ADDENDUM #3

Project Name: New Construction of:
West Whiteland Public Works Facility
121 Valley Creek Blvd.
Exton, PA 19341

Prepared for: West Whiteland Township
101 Commerce Drive
Exton, PA 19341

Date: August 25, 2023

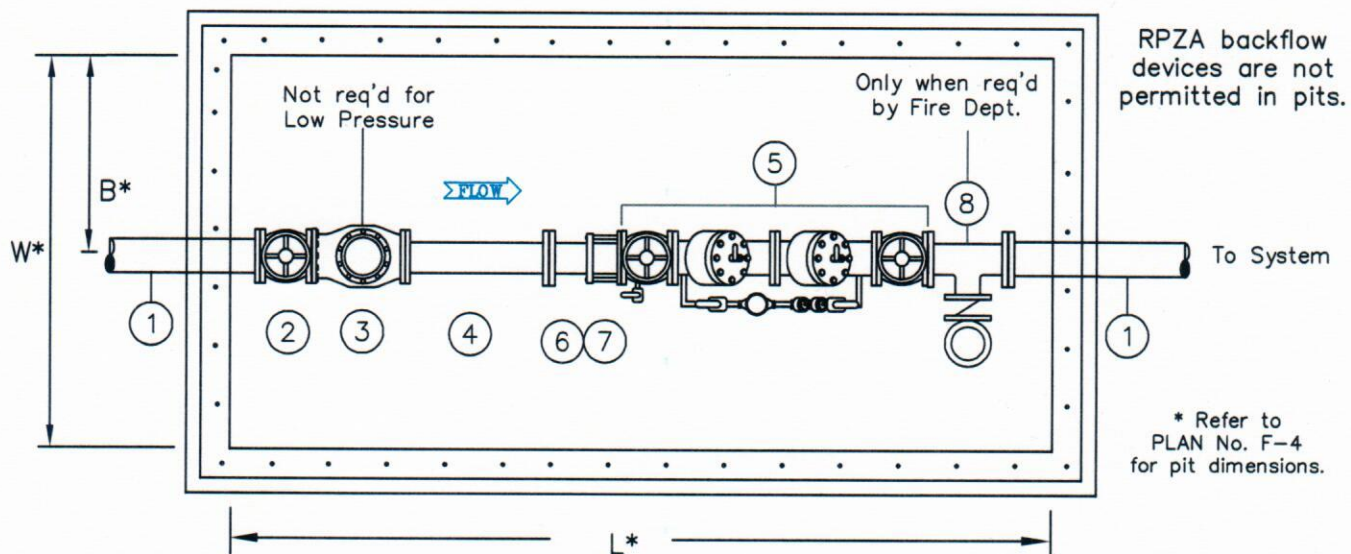
Response: Refer to drawing P603 and Specification Section 22 3000 for Oil/Water separator details and specifications."
- 3.028 **Question:** Water service information is not given on the Civil Drawings. Please provide the fire and domestic water pipe sizing, connection info to existing main, pipe sizing from connection to meter pit, and meter pit detail.

Response: Aqua will do the tap. See Meter Pit Details D-3 and F-3 from Aqua (attached as part of this addendum). Civil contractor to pick up at the curb. Piping sizes will be shown in plan in Conformed Set. Fire piping size will be 8" line into the hydrant and 6" from there; domestic water piping will be 4" for Building A and 3" for Building B.

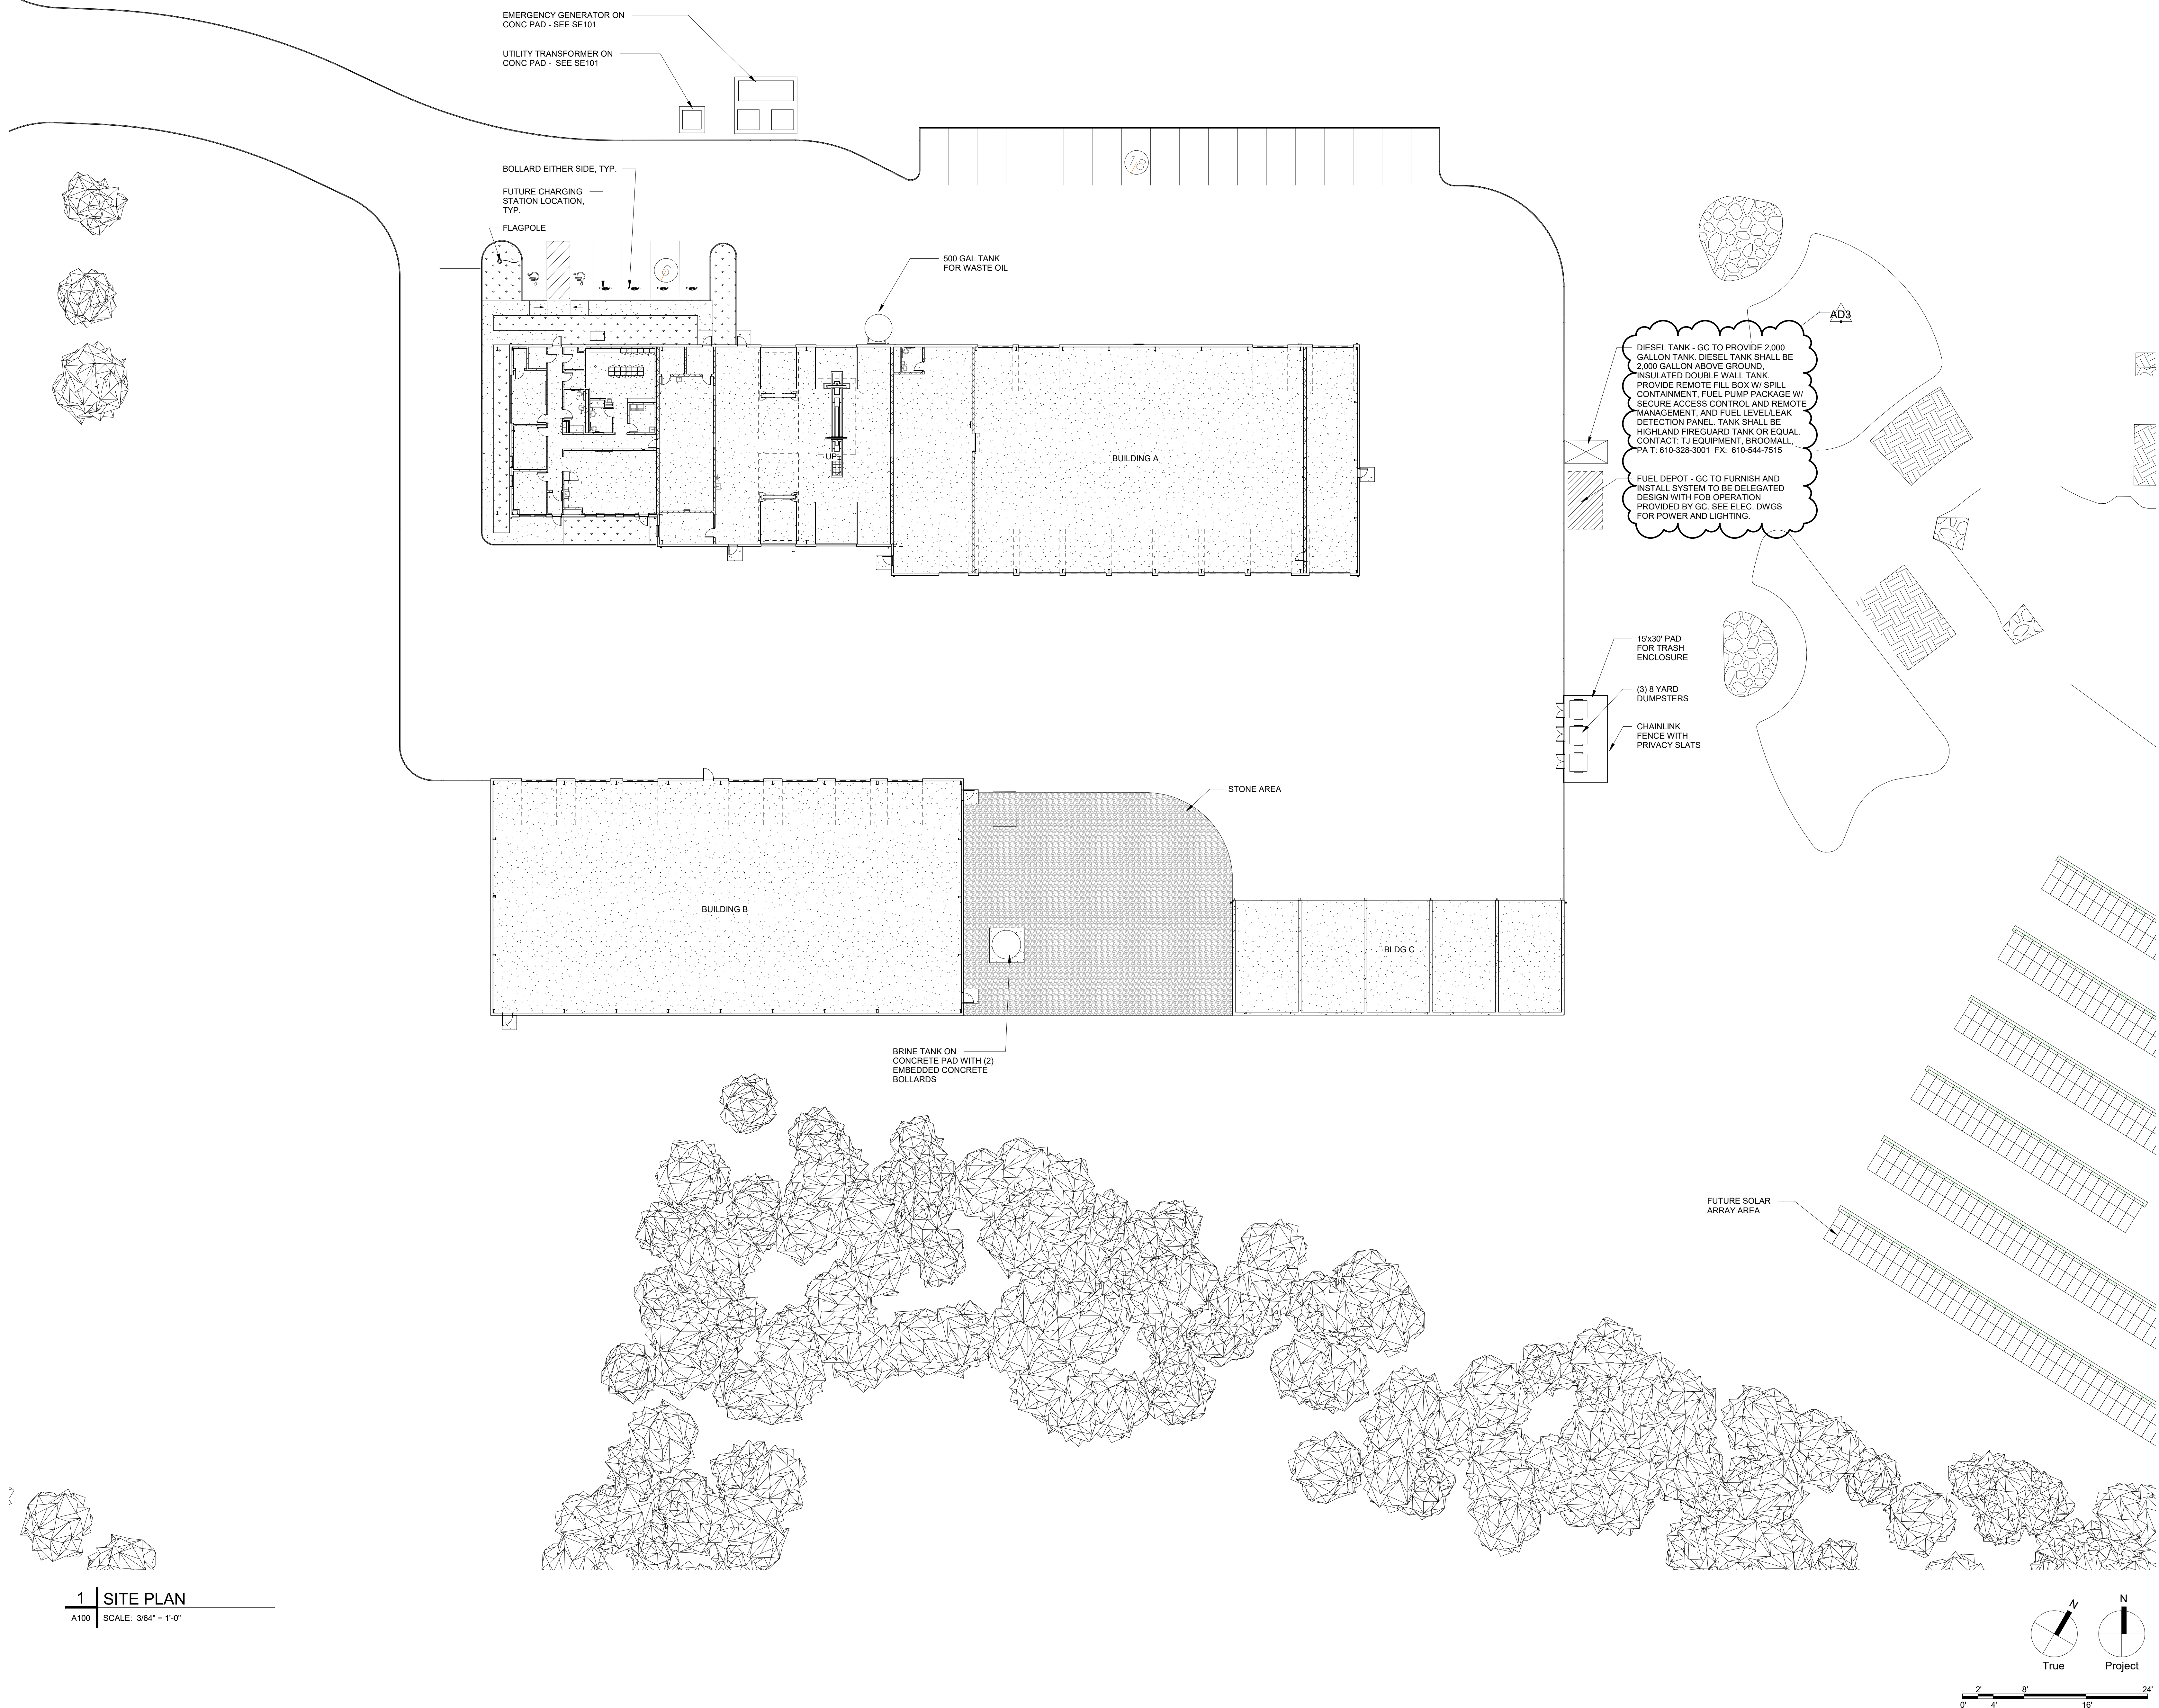
- 2.02 Drawing A100 – Site Plan; **REPLACE** sheet in its entirety. ADD the following language for Diesel Tank and Fuel Depot:
"DIESEL TANK - GC TO PROVIDE 2,000 GALLON TANK. DIESEL TANK SHALL BE 2,000 GALLON ABOVE GROUND, INSULATED DOUBLE WALL TANK. PROVIDE REMOTE FILL BOX W/ SPILL CONTAINMENT, FUEL PUMP PACKAGE W/ SECURE ACCESS CONTROL AND REMOTE MANAGEMENT, AND FUEL LEVEL/LEAK DETECTION PANEL. TANK SHALL BE HIGHLAND FIREGUARD TANK OR EQUAL. CONTACT: TJ EQUIPMENT, BROOMALL, PA T: 610-328-3001 FX: 610-544-7515."

FIRST FLOOR PLAN -
BUILDING A - SUPPLY
PIPING

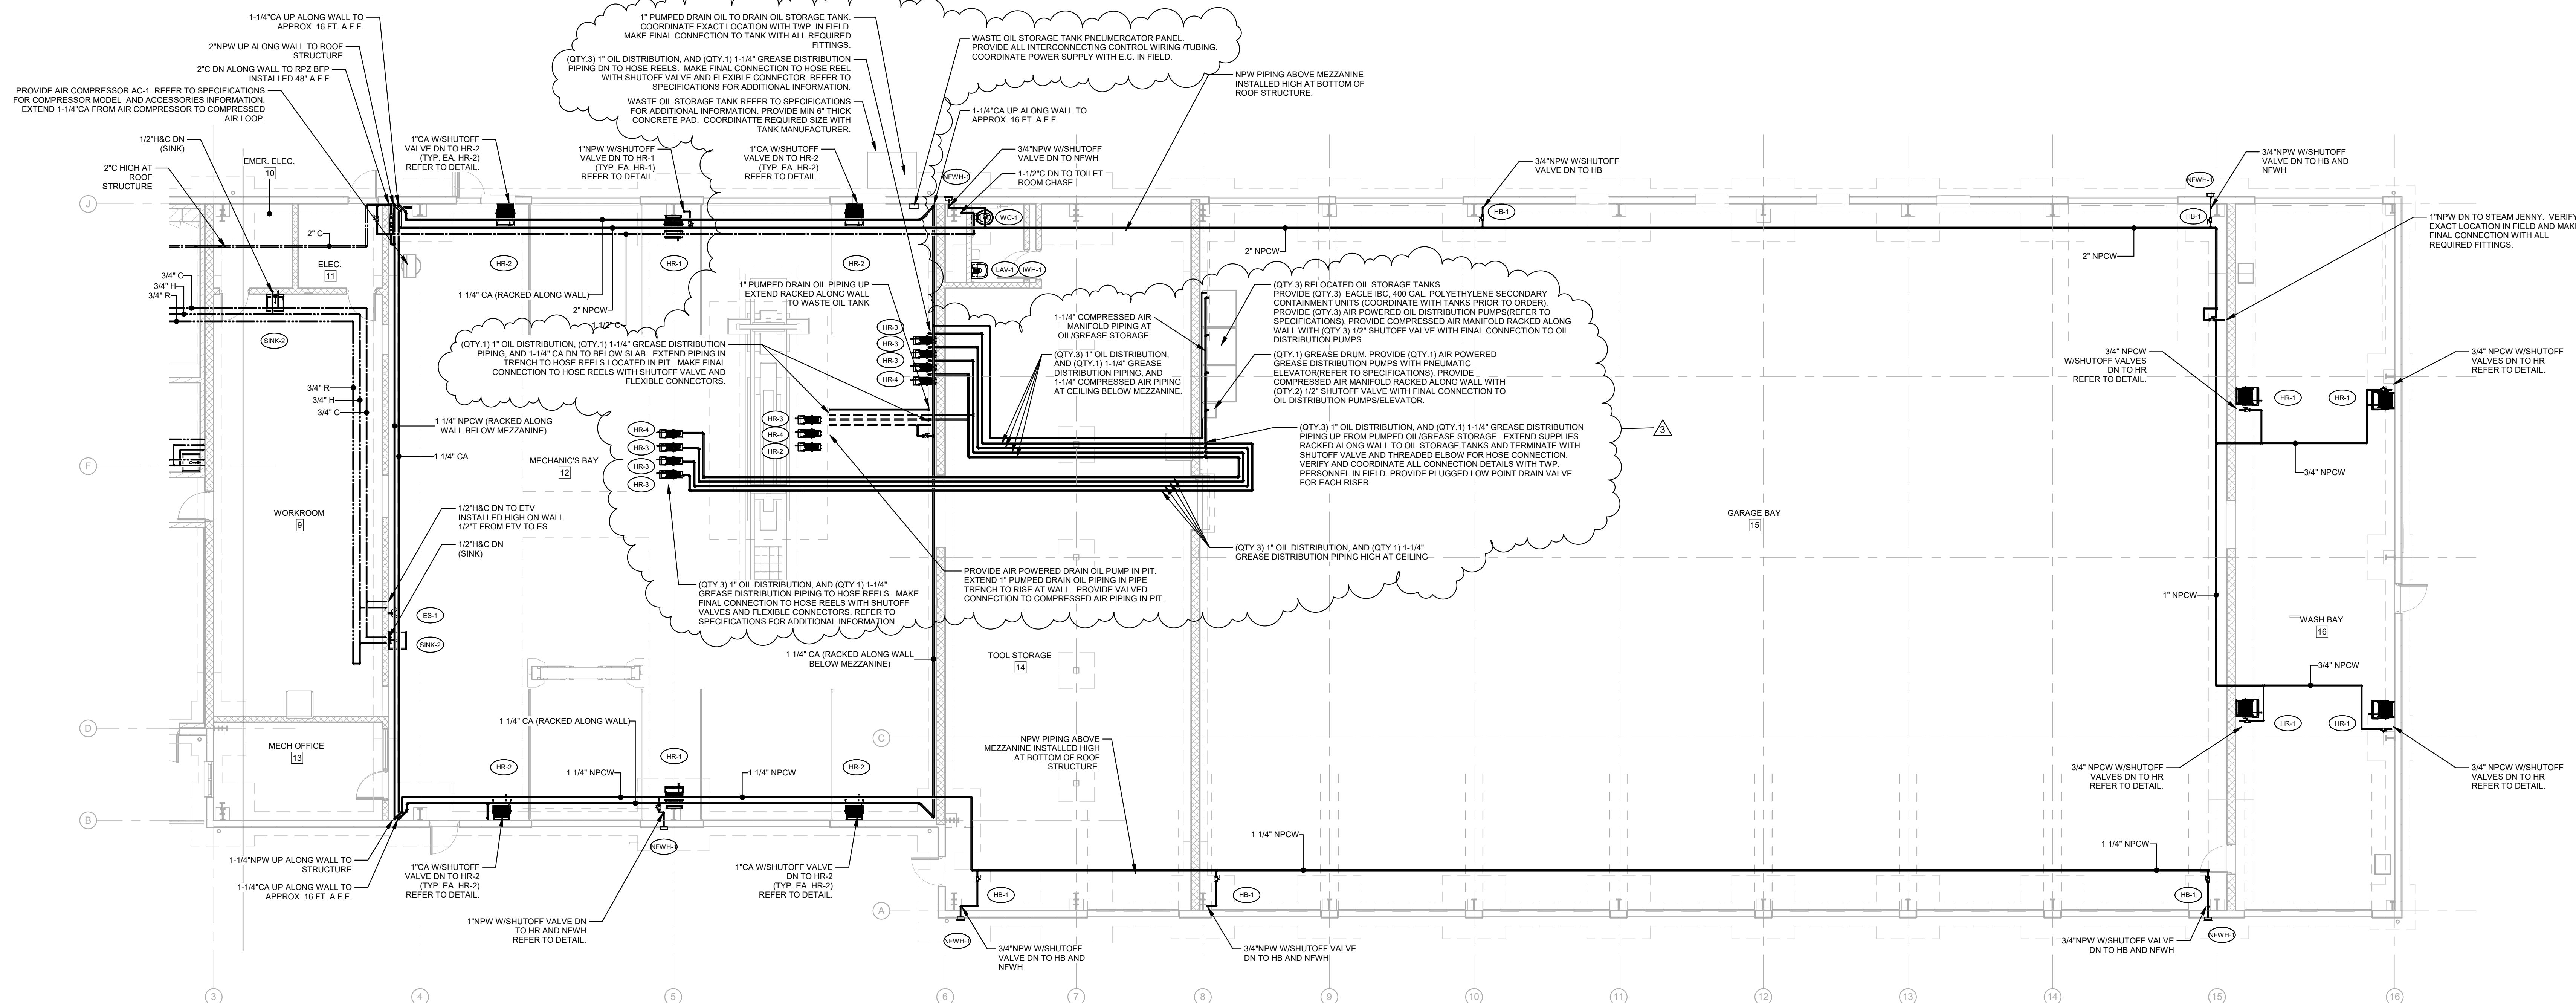
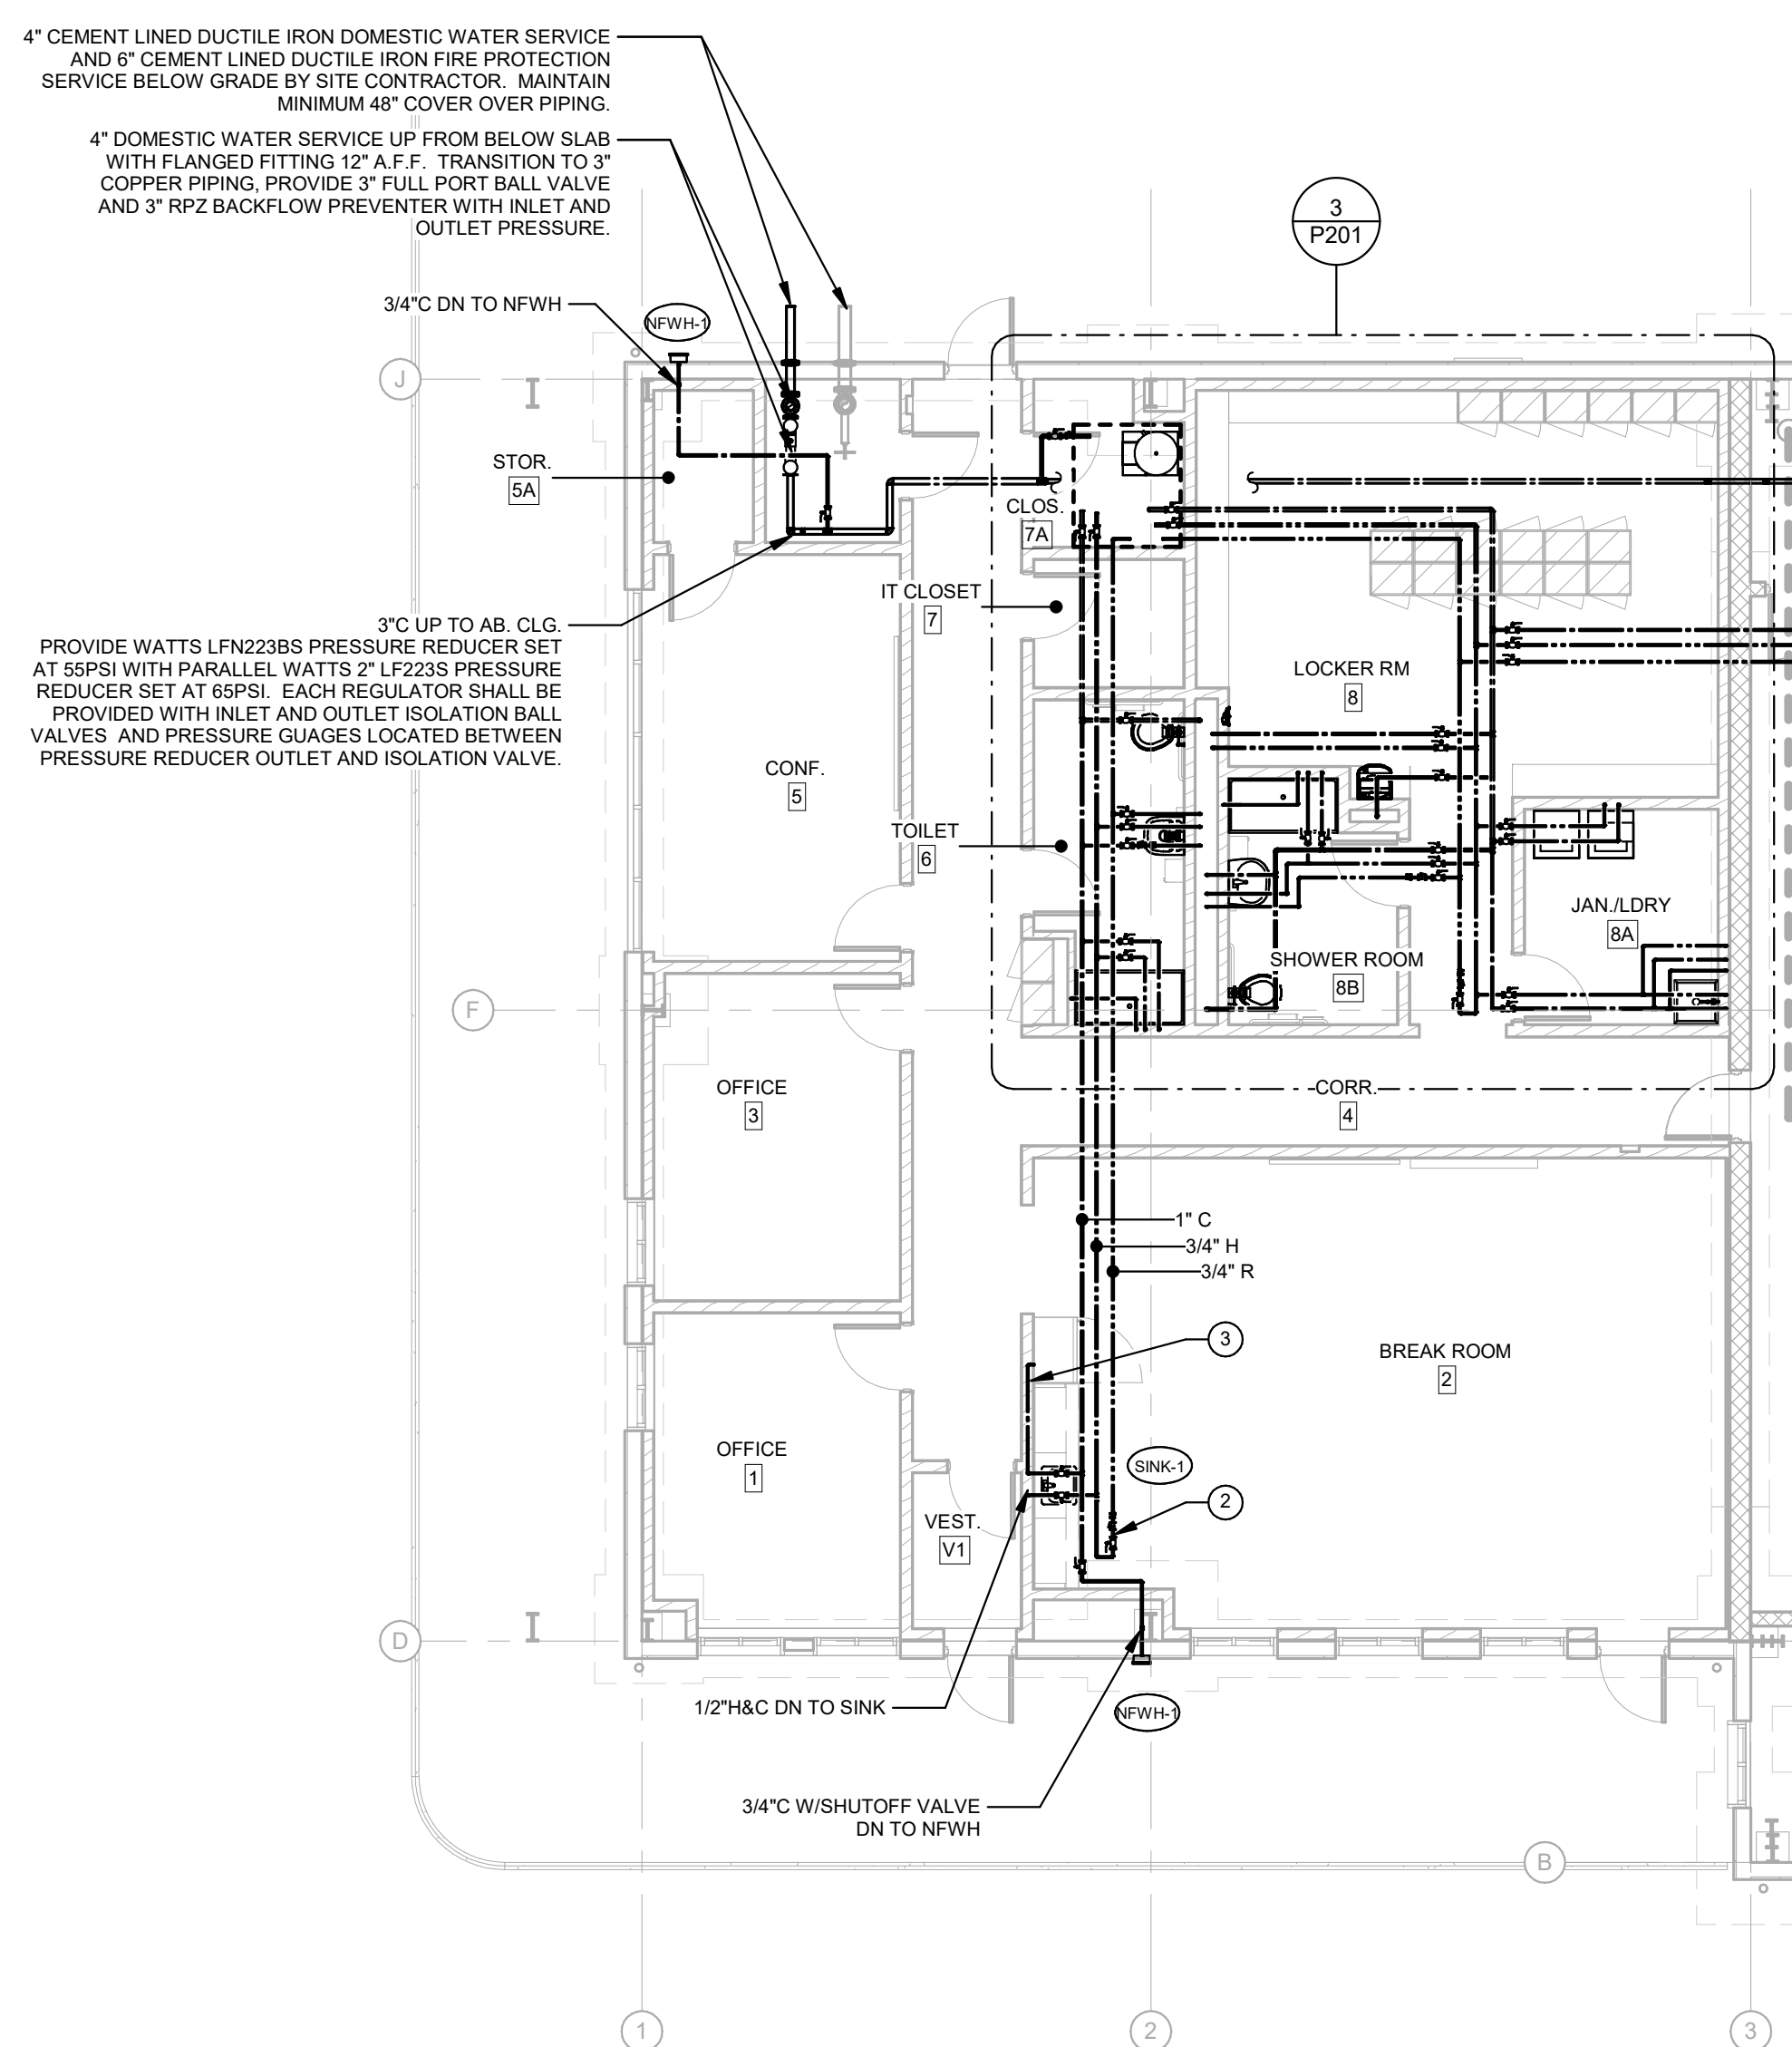
- 2.07 Drawing P201 FIRST FLOOR PLAN - BUILDING A - SUPPLY PIPING; **REPLACE** with attached revised drawing:
- 2.08 Drawing P202 FIRST FLOOR PLAN - BUILDING B - SUPPLY PIPING; **ADD** note to Brine tank as follows:
"P.C. SHALL RELOCATE AND INSTALL EXISTING BRINE TANK (OWNED BY WWT) FROM THE EXISTING TOWNSHIP MUNICIPAL COMPLEX.
CURRENT TANK LOCATION: MILLER WAY, EXTON, PA.
CONCRETE FOUNDATION PAD (BY G.C.)"
